Re: Sanitary Survey  
WVAWC - Huntington Dist  
PWSID No. WV3300608  
CABELL COUNTY

## **SANITARY SURVEY**

**PWSID No. WV3300608**

**WVAWC-HUNTINGTON DISTRICT**

Erosion at Base of Lavalette Tank

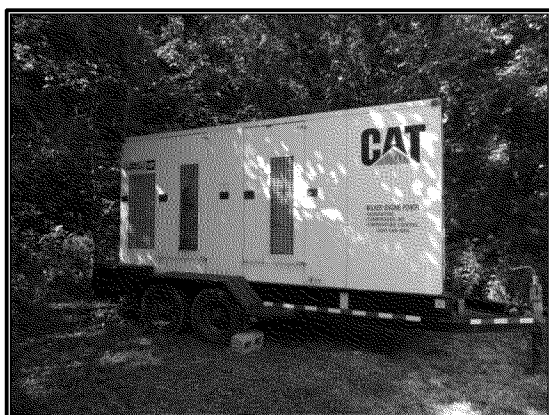
FACILITY	CATEGORY	DESCRIPTION
LAVALETTE TANK	Finished Water Storage	Inadequate overflow erosion control measures provided.
<b>Comments :</b> One of the main support footings has significant erosion due to overflowing of the tank. This support is directly below the overflow line. This areas should be backfilled and a proper splash guard and runoff control should be installed.		
FACILITY	CATEGORY	DESCRIPTION
LAVALETTE TANK	Finished Water Storage	Storage tank needs painting.
<b>Comments :</b> The support legs and main water line have numerous large rust areas. These areas should be cleaned and painted.
